City of Sebastopol Design Review Board Staff Report

Meeting Date: June 15, 2016
Agenda Item: 8A
To: Design Review Board
From: Jonathan Atkinson, Assistant Planner
Subject: Design Review: Mixed-Use Development
Recommendation: Approval with Conditions
Applicant/Owner: Katherine Austin/Clive Sharrocks
File Number: 2016-30
Address: 7631 Healdsburg Avenue
CEQA Status: Categorical Exemption: Section 15303: Class 3
Categorical Exemption: Section 15332: Class 32
General Plan: Office
Zoning: CO: Office Commercial

**DESIGN REVIEW PERMIT: 2016-30
Mixed-Use Development and Landscape Plan
7631 Healdsburg Avenue**

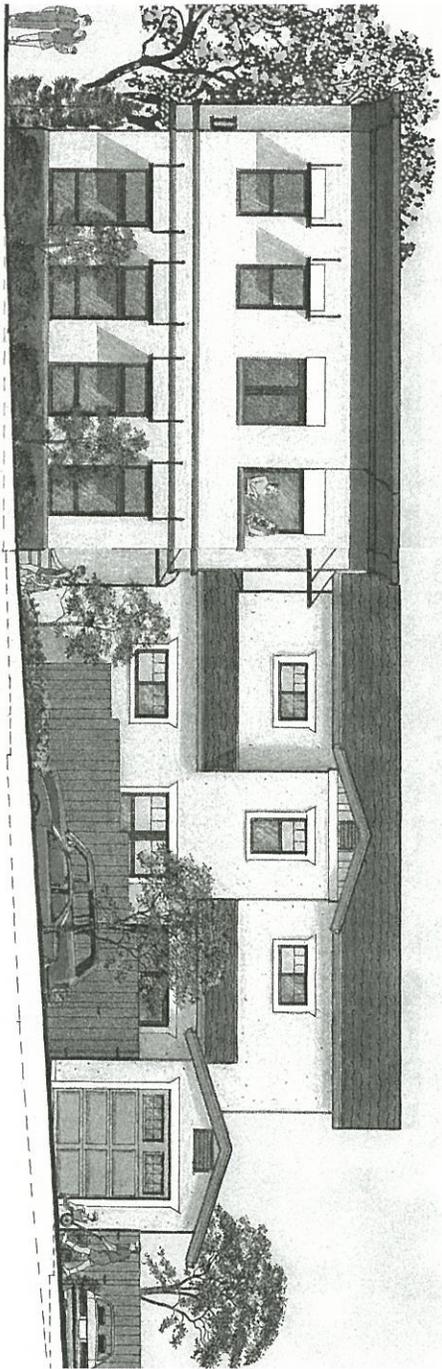
Because of the form and structure of the coast live oak, I agree that it would be impossible to retain on this lot without losing a significant percentage of buildable area. It is extremely low-branched, almost to the ground, and clearance pruning even for pedestrian access would remove most of its branches and crown. It is reasonable to remove this tree and protect the valley oak closer to the street.

Any necessary clearance or hazard reduction pruning on the valley oak should be done by a qualified tree service according to ANSI standards. I reviewed the landscape plan, and the mulch top dressing specified under the oak is the best landscape treatment for the valley oak tree. When fence and gate post locations are marked out on site within its dripline, they should be hand dug to determine if oak tree roots 2" or larger are growing in those locations. If any are found, the post should be shifted a few inches in line to avoid damaging them.

Current ANSI recommendation/specification for staking new trees is to minimize staking and cross bracing wherever possible. Where vandalism and high winds aren't a problem, single stakes on the windward side with as few ties as possible is recommended to encourage deep rooting and good trunk taper. The boxed coast live oaks (replacement trees) are specified to be low-branched, so they should be fine with minimal staking. Tree holes should be no deeper than the rootball, but 2-3 times the width.

The project is well-designed and appropriate in regard to the valley oak to be preserved and the landscaping.
